# Environmental Impact Statement

## Getty and Cities Service Shale Oil Projects

**FINAL**

**5 October 1984**

FIGURE 4  
GCC JOINT VENTURE  
INTAKE PLAN

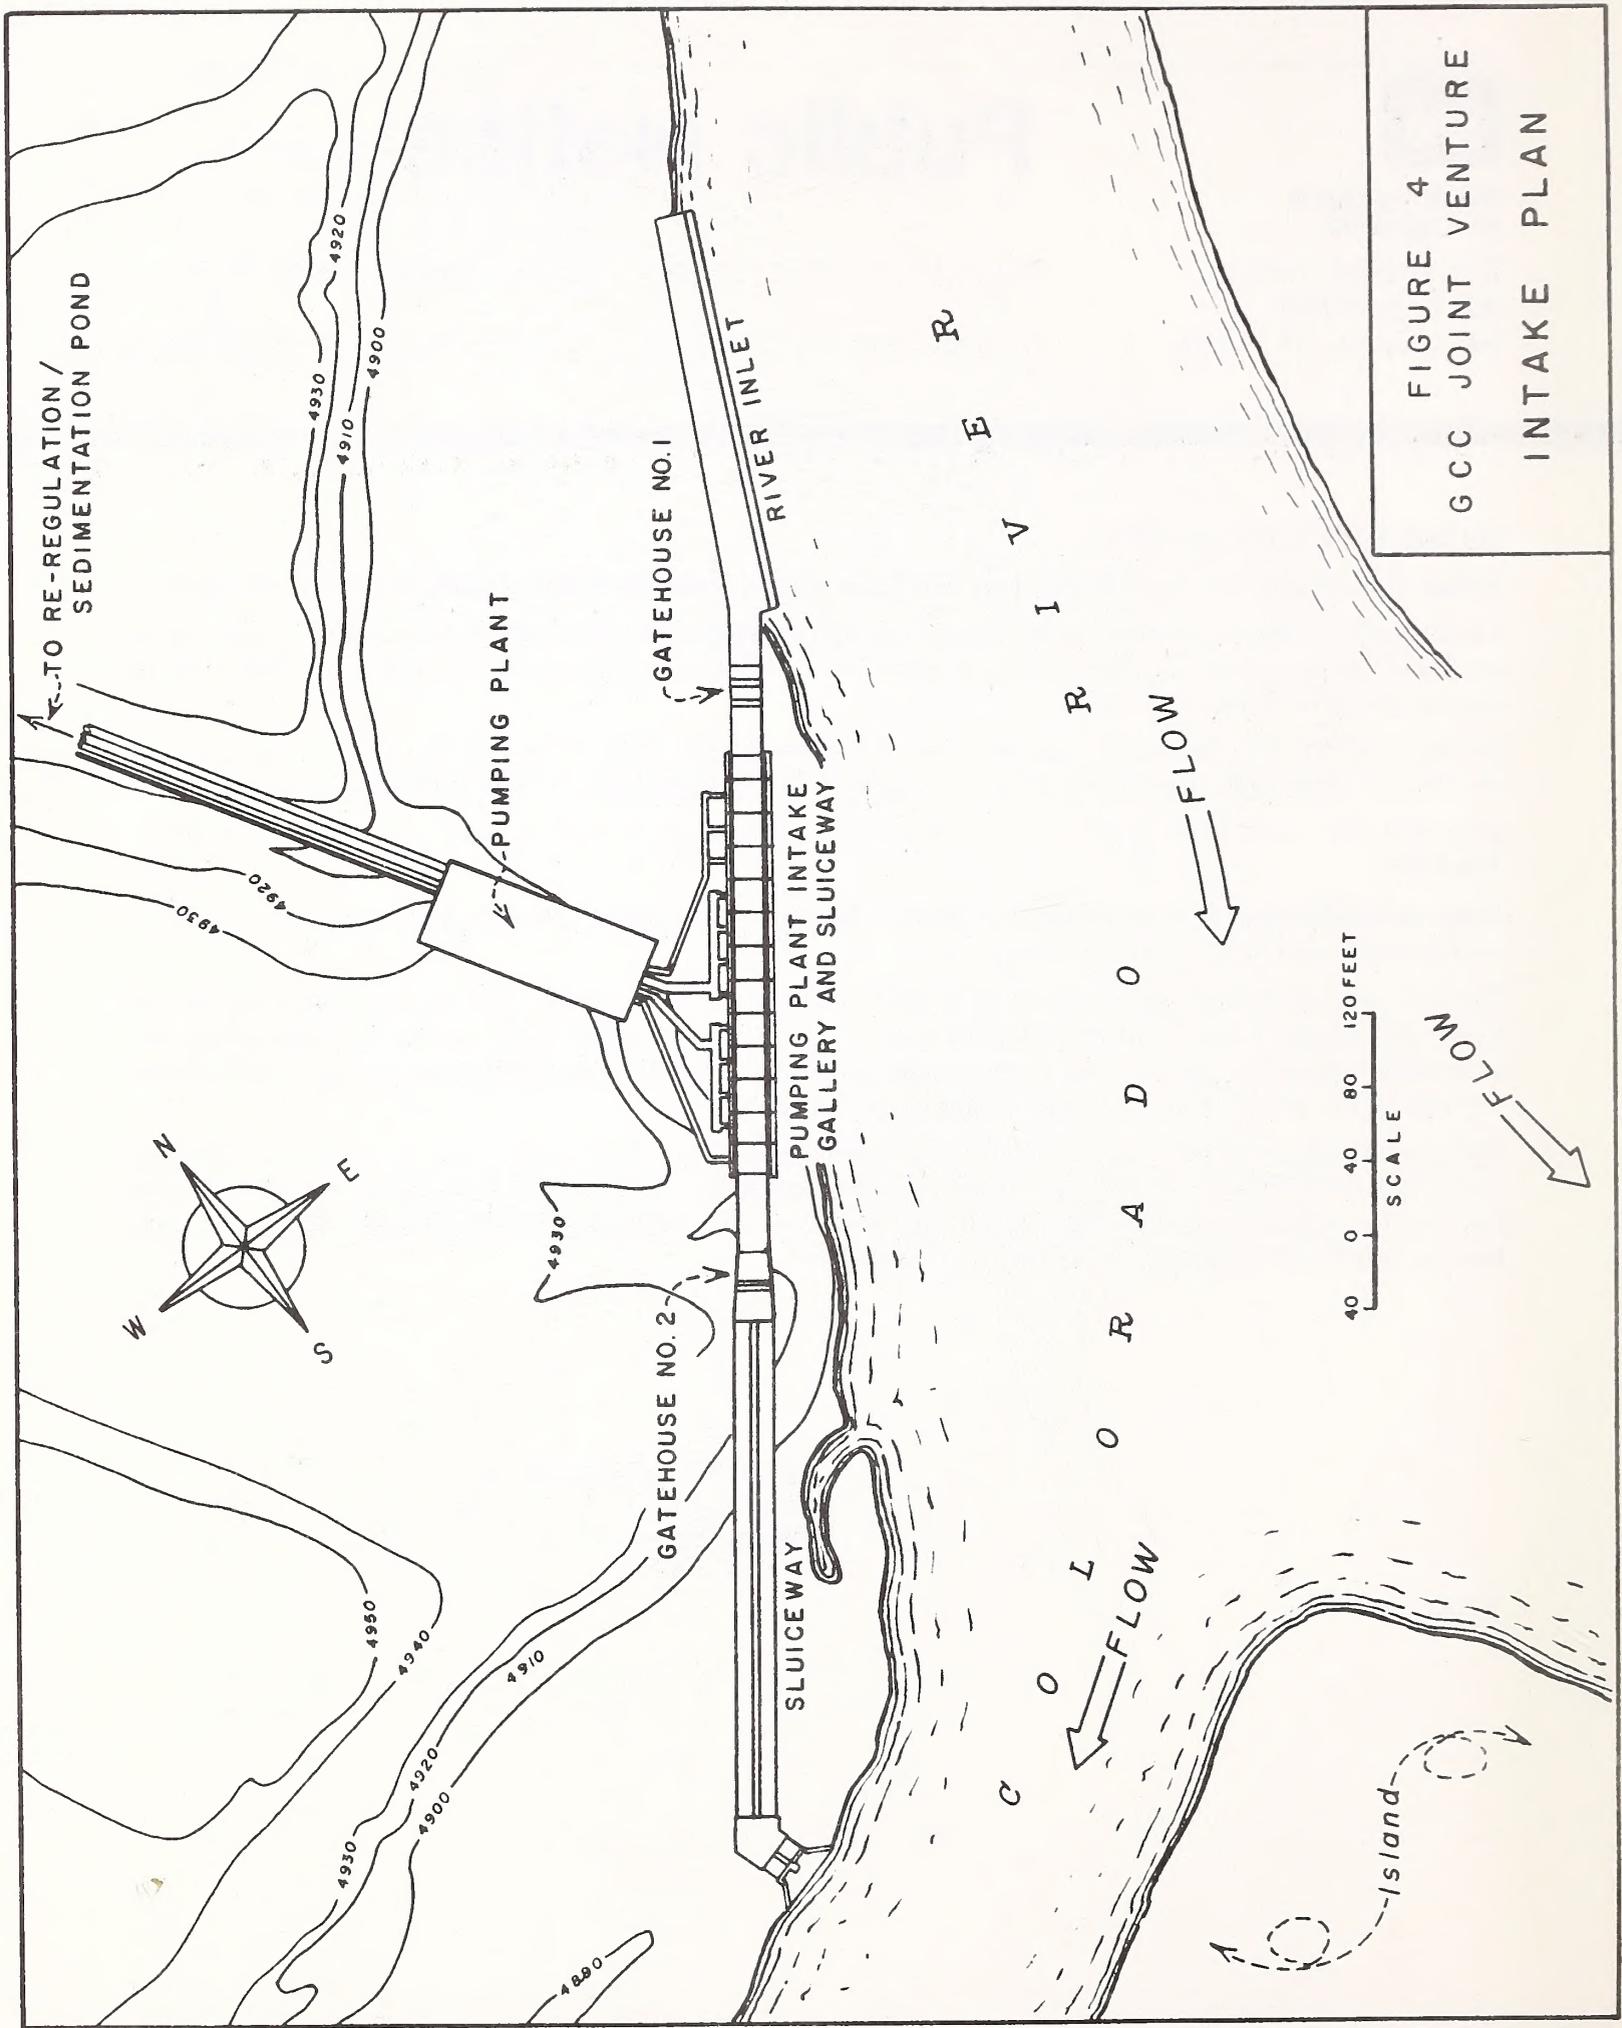
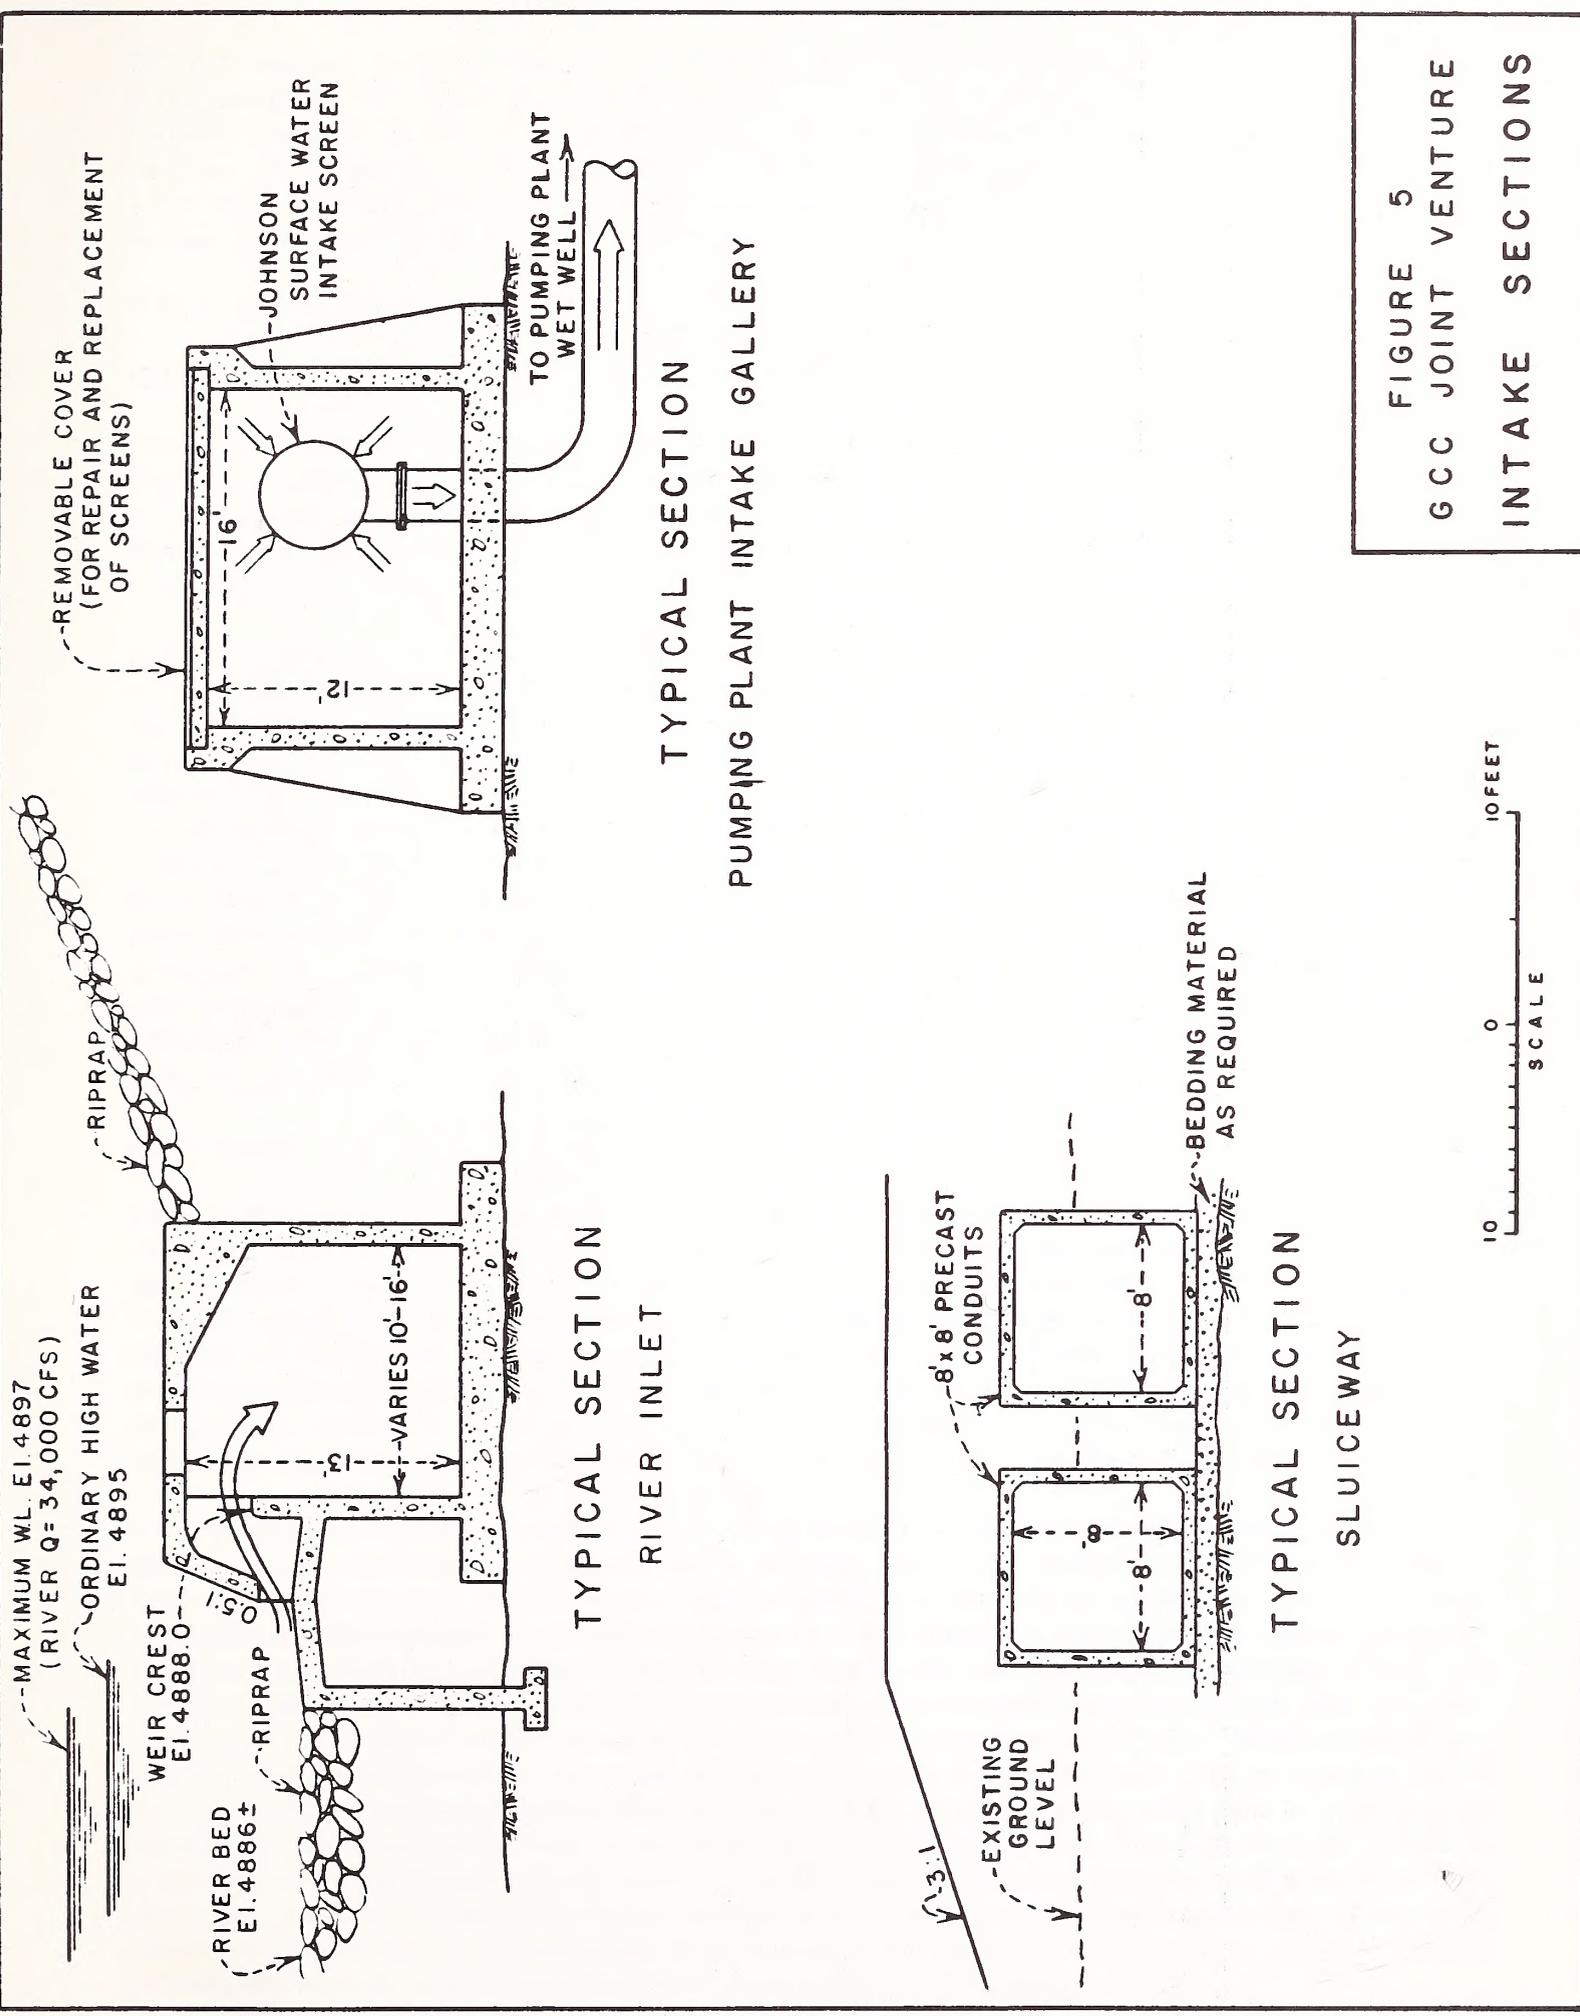
**Notice of Modification of Plans for the GCC's water diversion facility on the Colorado River.** New plans are shown on the attached drawings, figures 4 and 5.

Figure 2.3-5 Mine Progression (years), Getty Shale Oil Project.

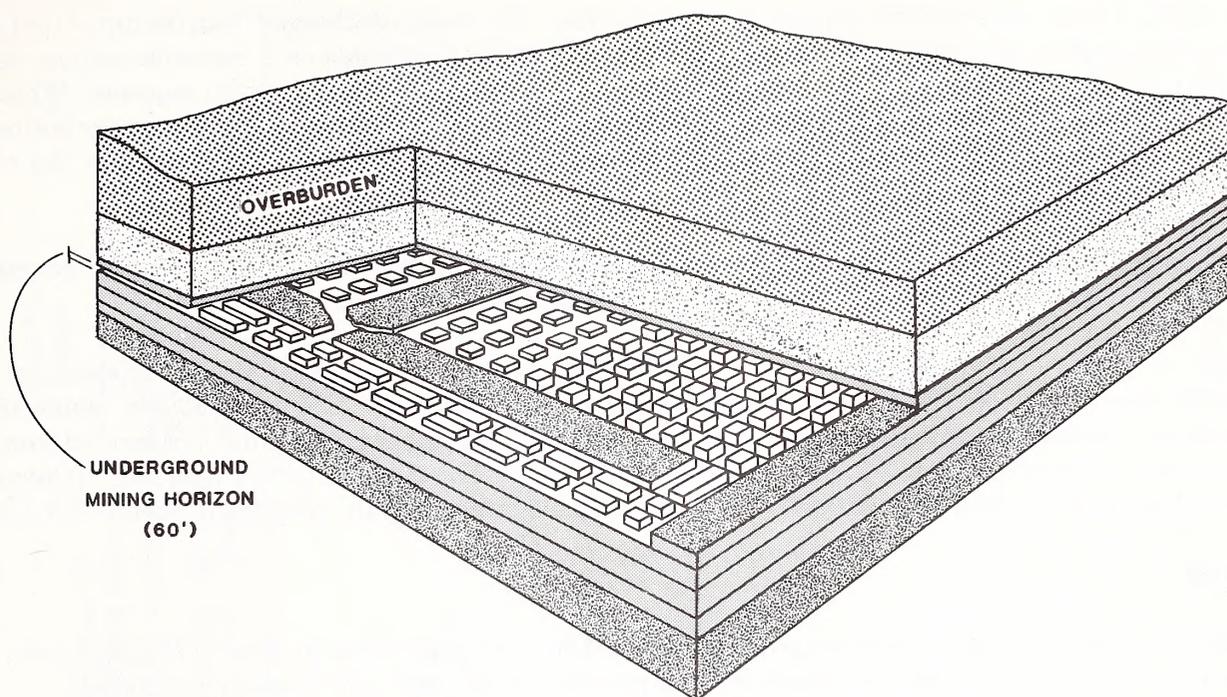
- 2 Page 2-16, Figure 2.3-5: Add footnote: Underground Mining will advance up to the Getty property line in accordance with standard mining practice and in compliance with Colorado Mining Law.

Figure 2.3-8 Union Oil "B" Retort Material Balance, Getty Shale Oil Project.

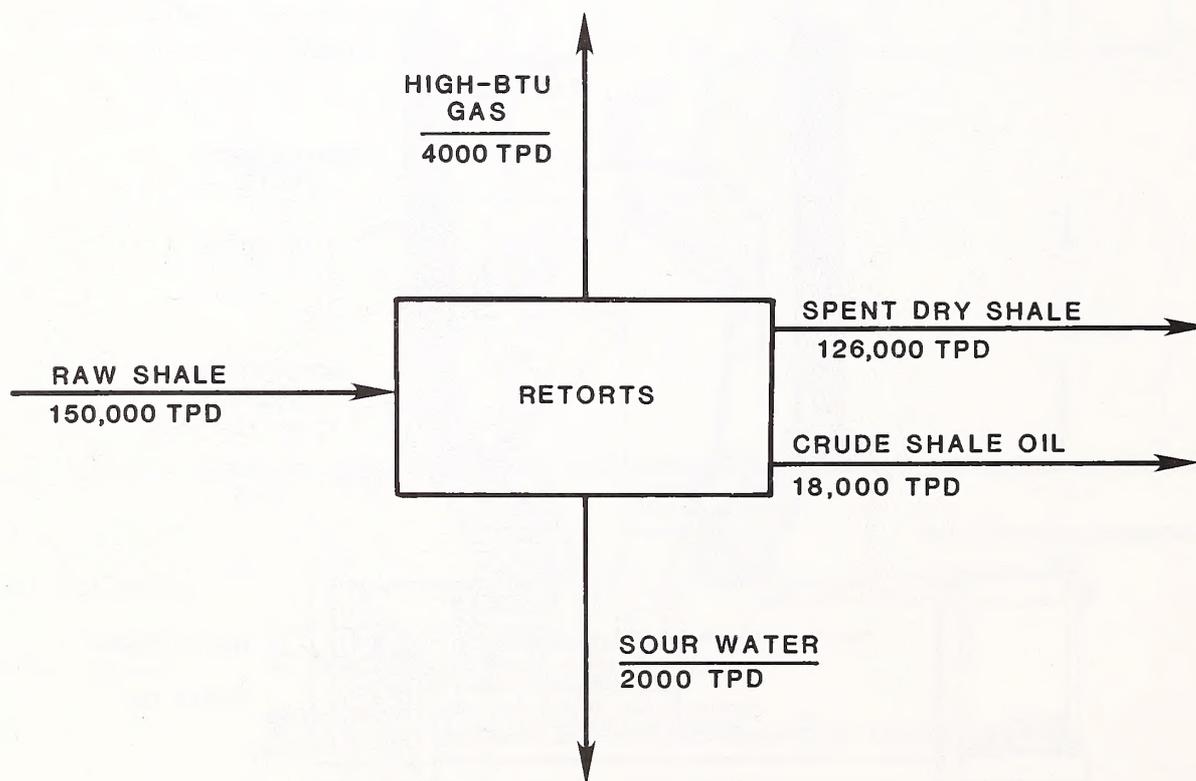
- 2 Page 2-18, Figure 2.3-8: The material balance that is presented is the same as for Figure 2.3-20 which is Cities. The correct Getty raw shale input is 150,000 TPO with outputs of Crude Shale Oil of 18,000 TPO, Spent Dry Shale of 126,000 TPO, Sour Water of 2,000 TPO, and High - BTU Gas of 4,000 TPO.

Figure 2.3-19 General Arrangement of the Proposed Project Facilities, Cities Service Shale Oil Project.

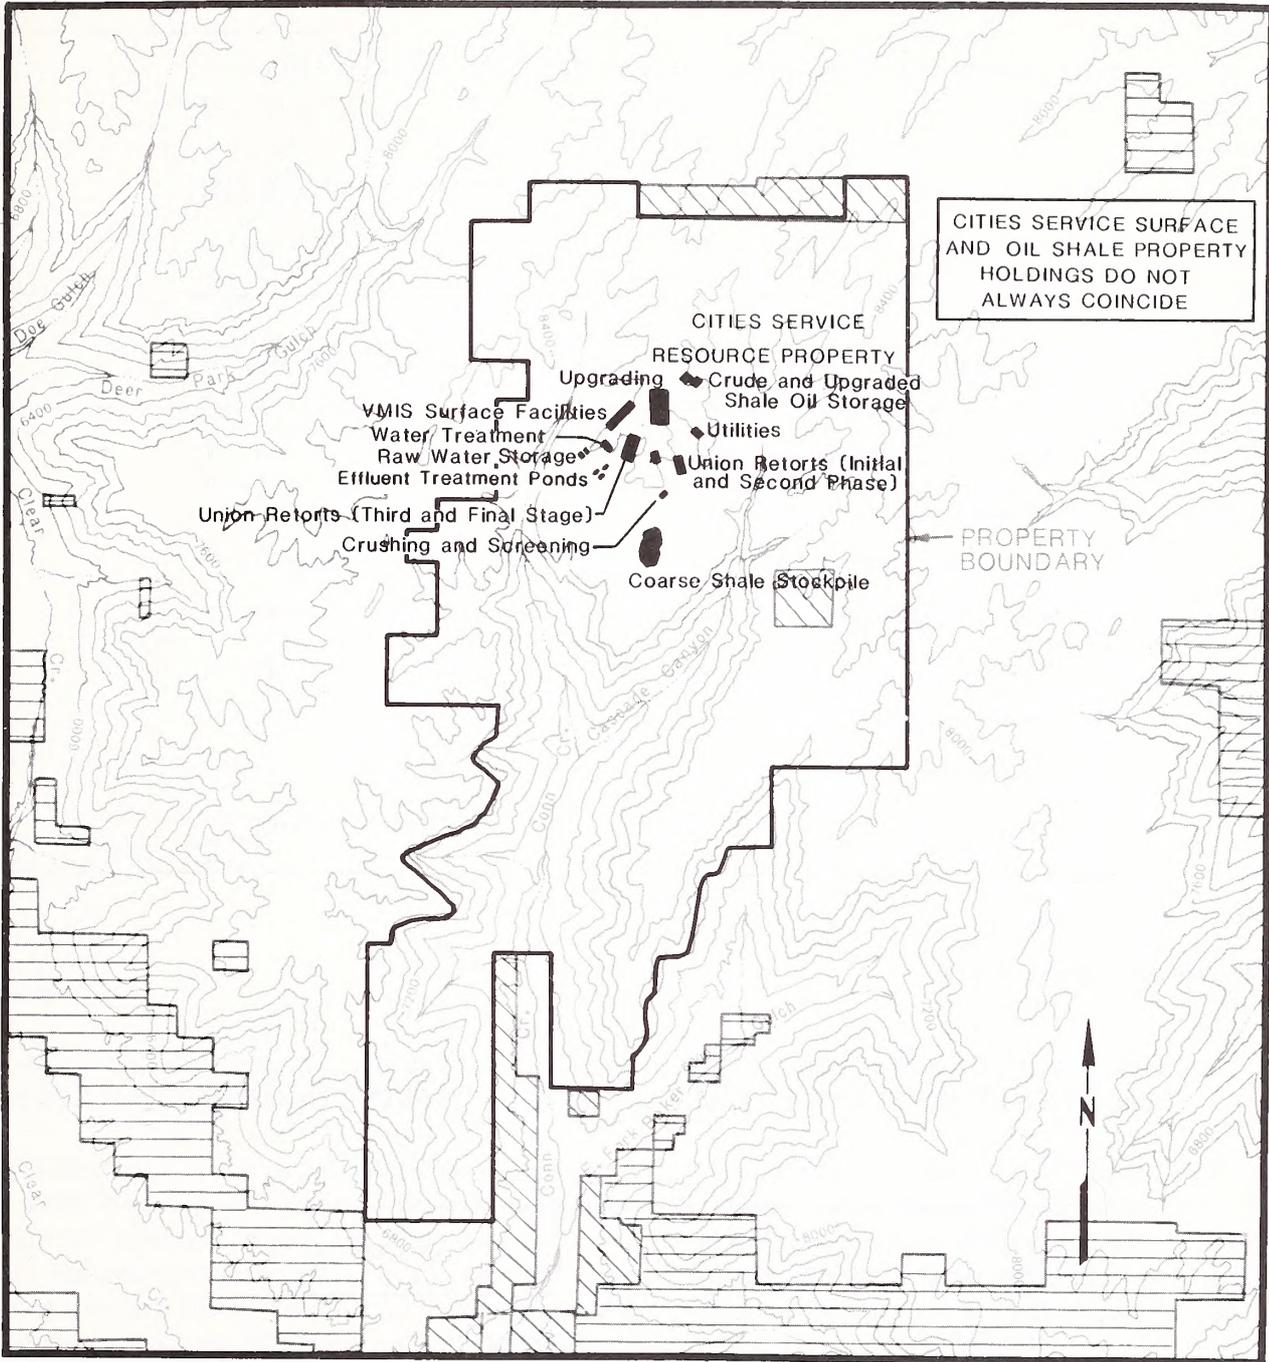
Figure 2.3-19, page 2-71, should be revised as follows:
